Subject: Waterford 3 SES
Docket No. 50-382
License No. NPF-38
License Amendment Request NPF-38-181
Discrepancy Regarding the Design and Testing of Instrument
Sensing Lines Penetrating the Primary Containment

DESCRIPTION AND SAFETY ANALYSIS OF PROPOSED CHANGE NPF-38-181

ATTACHMENT C

Visual Representation of the Proposed Plant Modification

STEP 1: WITH CVR401A & B SHUT, MODIFY C-4

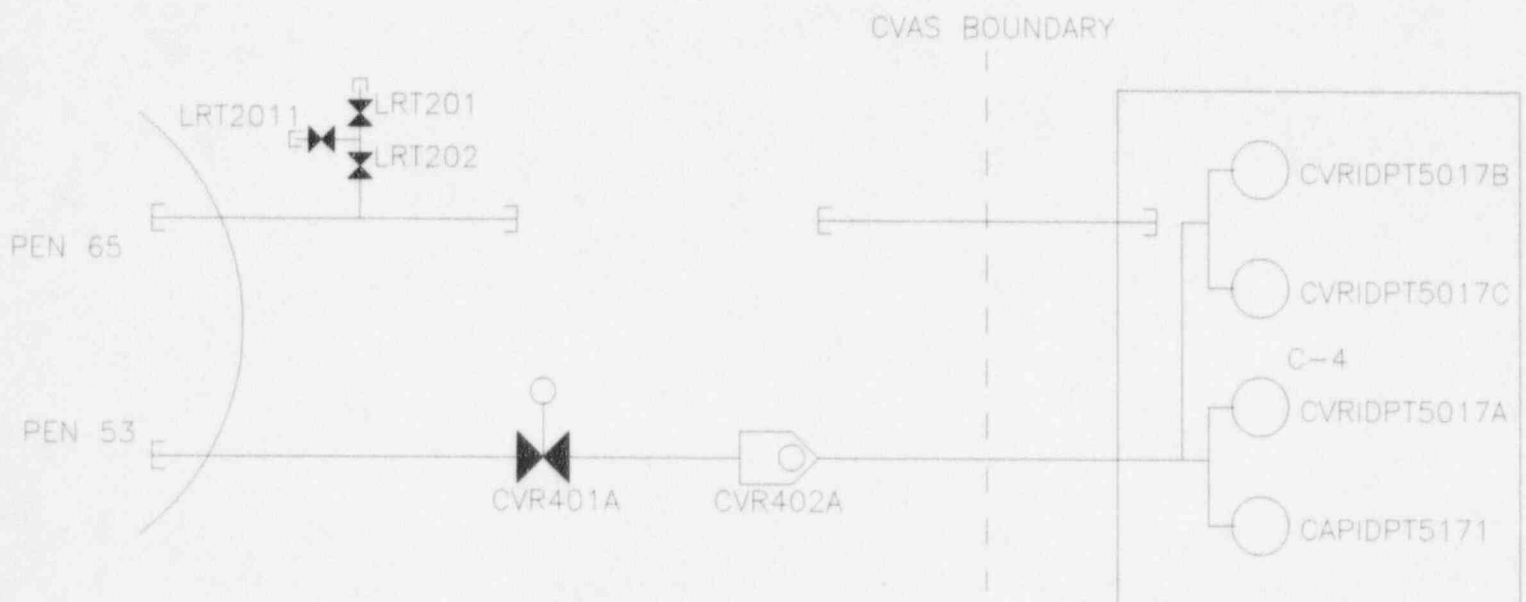
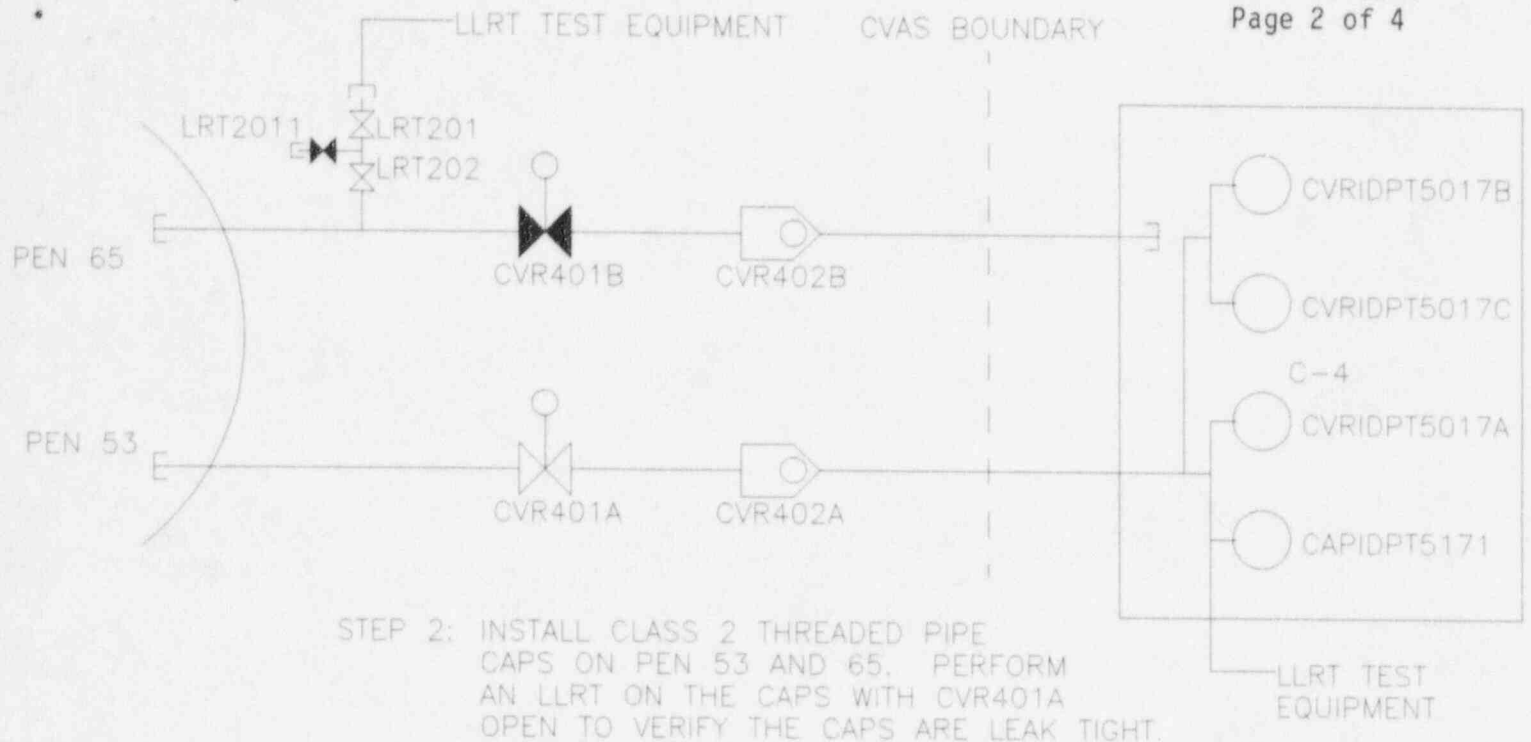
1. The monitoring line from penetration 65 will be cut and capped in the C-4 instrument cabinet. Instruments CVR-IDPT-5017B and CVR-IDPT-5017C will be tied in to the monitoring line from penetration 53.

STEP 3: CUT CVR401B AND CVR402B OUT OF THE SYSTEM AND CAP THE REMAINING LINES

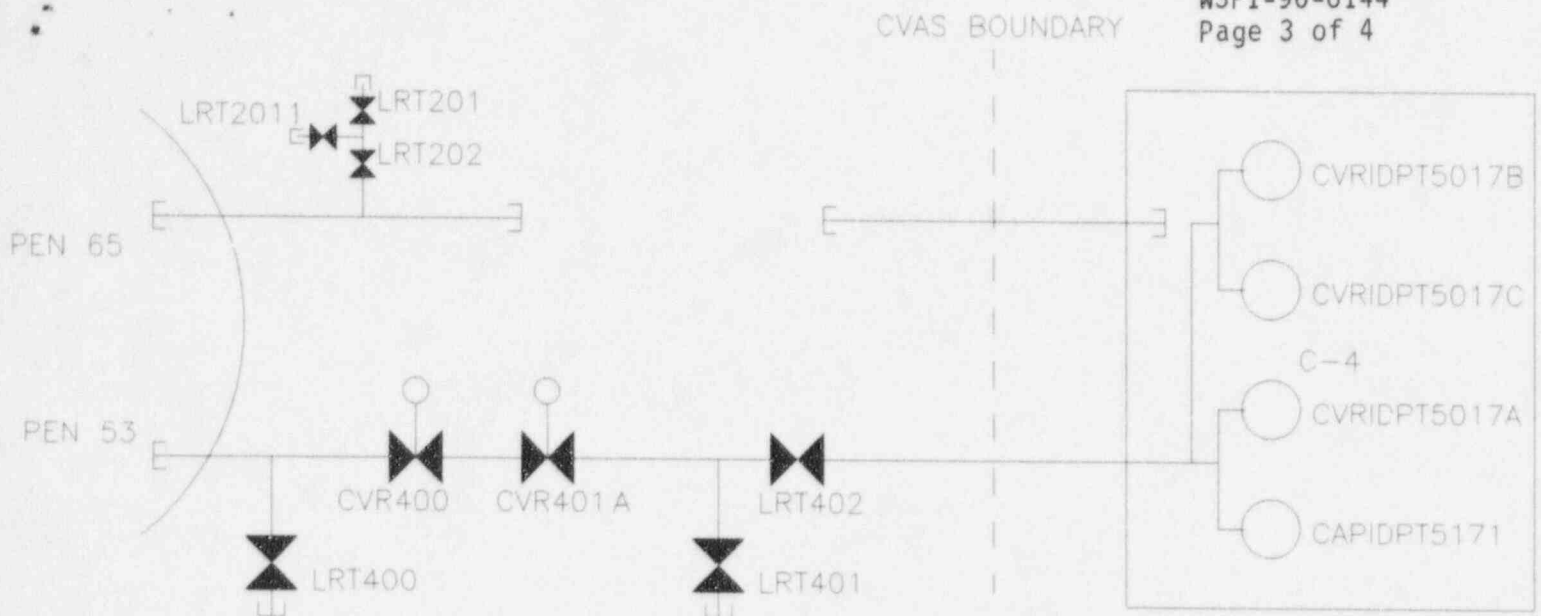
3. CVR 401B and CVR 402B will be cut out of the system and line end caps will be installed. The line in penetration 65 will have a welded pipe cap installed outside containment. The remaining portion of this line will have a welded pipe cap on the line end located within the CVAS boundary.

STEP 4: INSTALL A SOLENOID VALVE UPSTREAM OF VALVE CVR401A. INSTALL REQUIRED VALVES FOR LLRT TEST CONNECTIONS. RENAME CVR401A CVR401

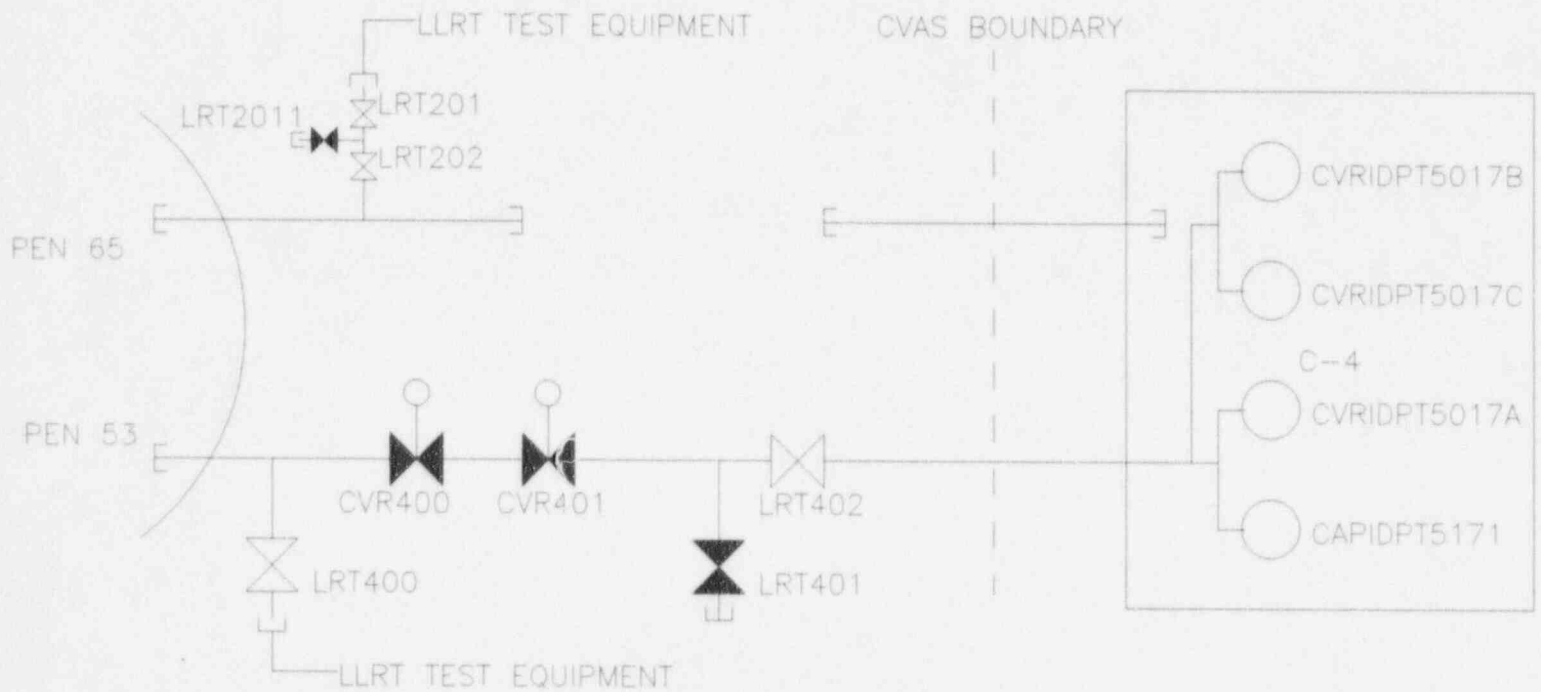
4. A solenoid valve will be installed upstream of CVR 401A and LLRT test connections will be installed. The tubing and valves from containment up to and including the outer most containment isolation valve will meet ASME Section III, Class 2, seismic Category I criteria. The excess flow check valve CVR 402A will be removed from the penetration 53 line and replaced with LRT 402 manual valve.

STEP 5: PERFORM LLRT ON PENETRATION 65 CAP AND VALVES CVR400 AND CVR401.

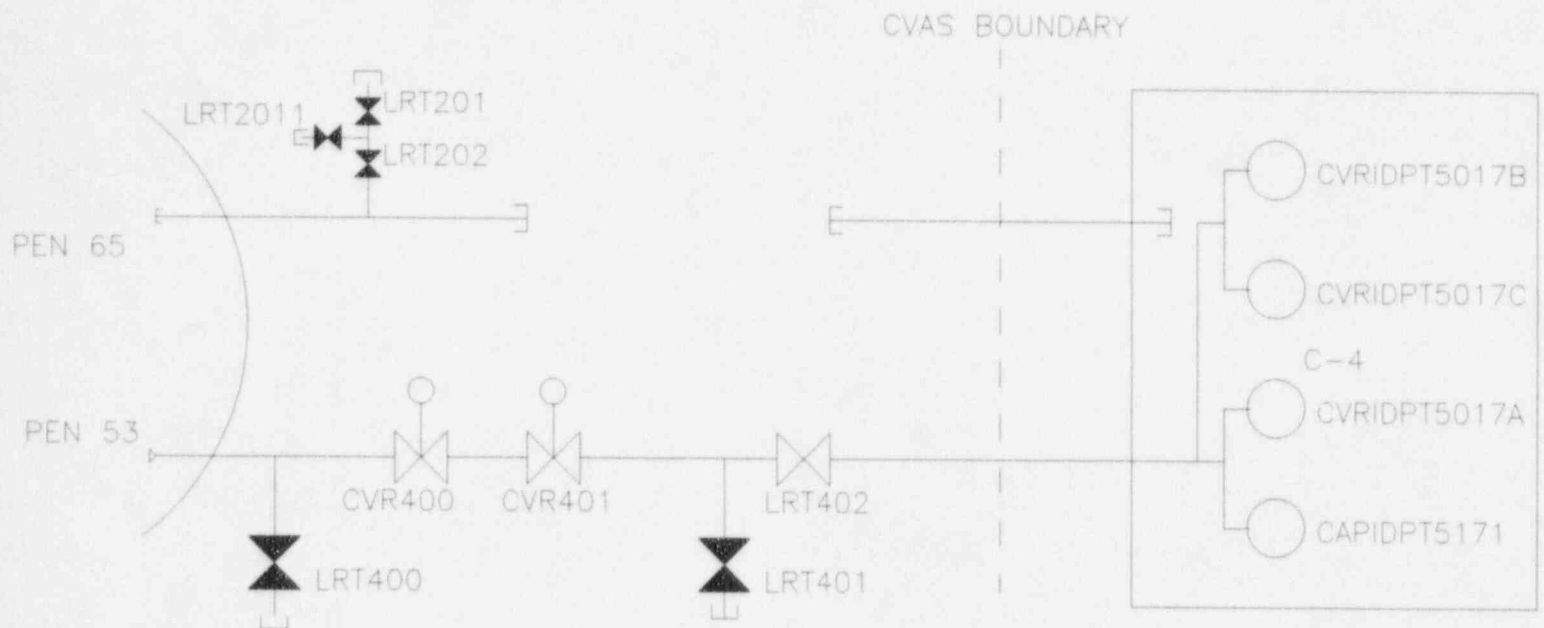
5. A LLRT test will be performed on penetrations 53 and 65.
6. The power to the new series isolation valve will be attached and appropriate operability testing will be performed. The cap inside containment on the monitoring line in penetration 53 will be removed. Upon completion of this plant modification an operability test of the CVAS boundary will be performed in accordance with the requirements in the technical specifications.

STEP 6: REMOVE THE PIPE CAP FROM THE INSIDE OF PEN 53
